Work Order ID 94879

Item Name: Crosstube Turning Detail

DART AEROSPACE LTD	Work Order:	94879
Description: Crosstube Assembly (205/212/412 High Fwd)	Part Number:	D212-664-141
Inspection Dwg: D212-664-141 Rev: D		Page 1 of 2

DRAWING NO. D212-664-141	TITLE XTUBE ASSY (205/212/412 HI FWD)	REV. D	DART AEROSPACE LTD ENGINEERING ORDER		D.E.O. NO. D212-664-141-D-1	SHEET NO. SHEET 1 OF 2	SCALE NTS
DRAWN	CHECKED	MFG. APPR.	APPROVED	DE APPR.	DATE	DATE	DATE
11.04.07	11.04.11	11.04.12	11/04/12	11.04.12	11.04.12	11.04.12	11.04.12

**D212-664-141/-141B
ASSEMBLY DETAIL**

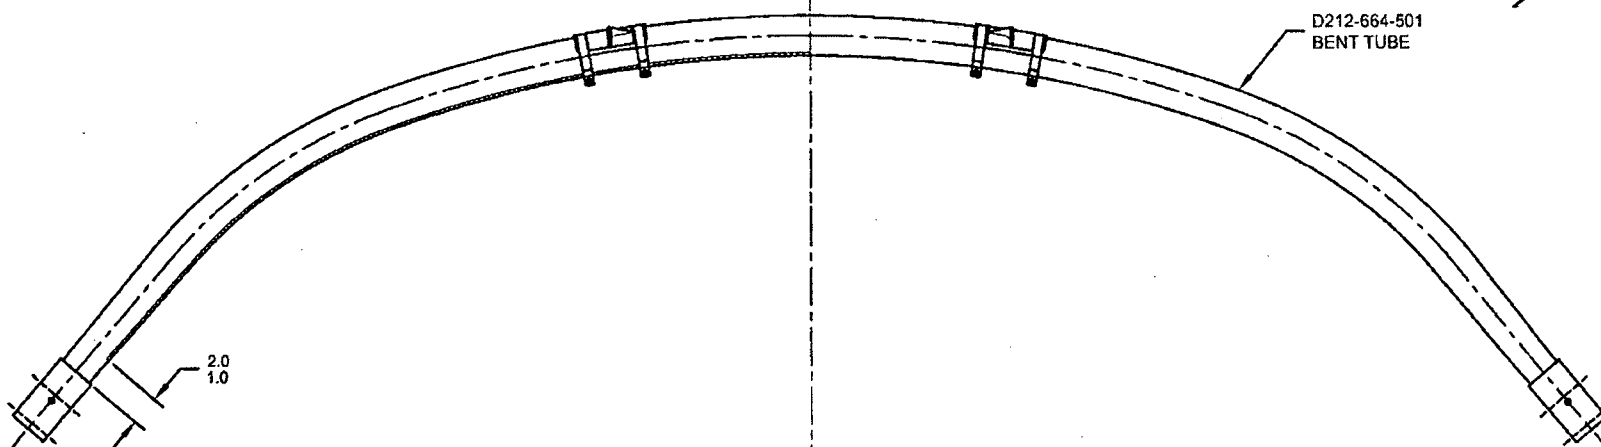
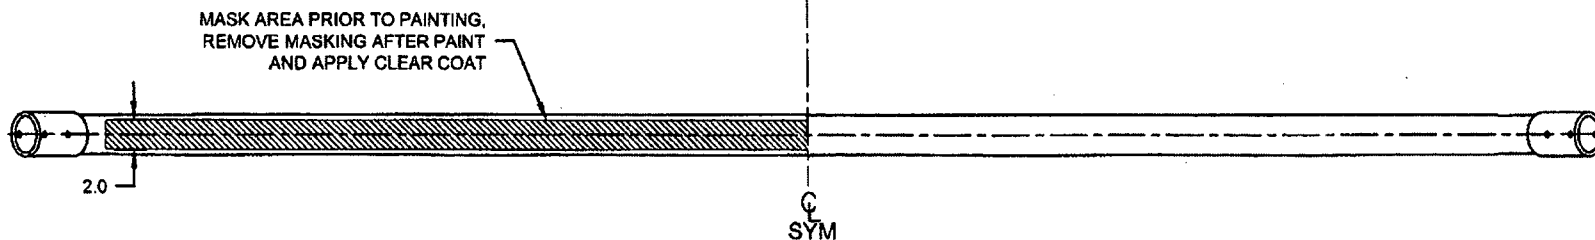
ADD AN INSPECTION WINDOW TO UNDERSIDE OF CROSSTUBE.

NOTES 2 OF SHEET 1 IS AMENDED AS FOLLOWS:

IS:

WAS:

- 2) FINISH: CHEMICAL CONVERSION COAT PER DART QSI 005 4.1
PRIME INSIDE AND OUTSIDE PER DART QSI 005 4.2
MASK UNDERSIDE OF CROSSTUBE AS SHOWN (HATCHED AREA) AND
PAINT OUTSIDE PER DART QSI 005 4.2
REMOVE MASKING AND APPLY CLEAR COAT

- 2) FINISH: CHEMICAL CONVERSION COAT PER DART QSI 005 4.1
PRIME INSIDE AND OUTSIDE PER DART QSI 005 4.2
PAINT OUTSIDE PER DART QSI 005 4.2
